**Environmental
Protection Agency**

September 23, 2010

RE: Wayne County
Upper Muskingum River Watershed
Baughman Twp.
BAU-TR-299-1.39 (Huprick Rd)

Fig 5 (LEFT). This off-site spoil area is not shown on the SWP3.

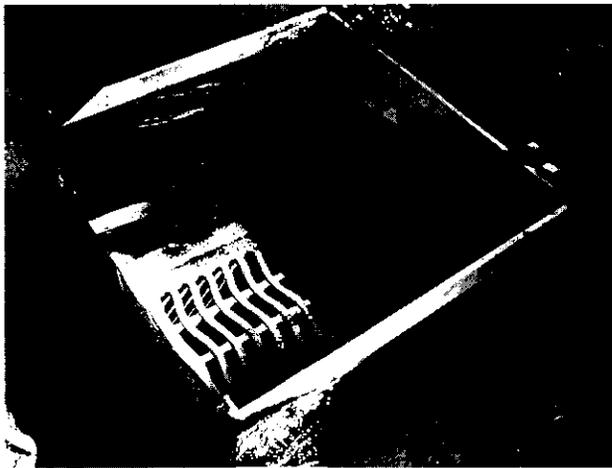
- **Off-site spoil area.** Spoils (excess soil) from this project are being taken off-site onto an adjoining property. The SWP3 has not been revised to provide information about this off-site spoil area. Part III.G.1.n.i of the NPDES permit requires the SWP3 to contain a site map showing the limits of earth-disturbing activity on all associated off-site borrow or spoil areas that are not addressed by a separate NPDES permit. Further, BMPs must be provided for storm water discharges from areas of associated activities. We noted that silt fence has been installed to control sediment-laden discharges. Please be sure

Fig 6 (RIGHT). Although some silt fence has been placed at the toe of the spoil area, the silt fence must be extended to the north to protect what appears to be an ephemeral stream channel.
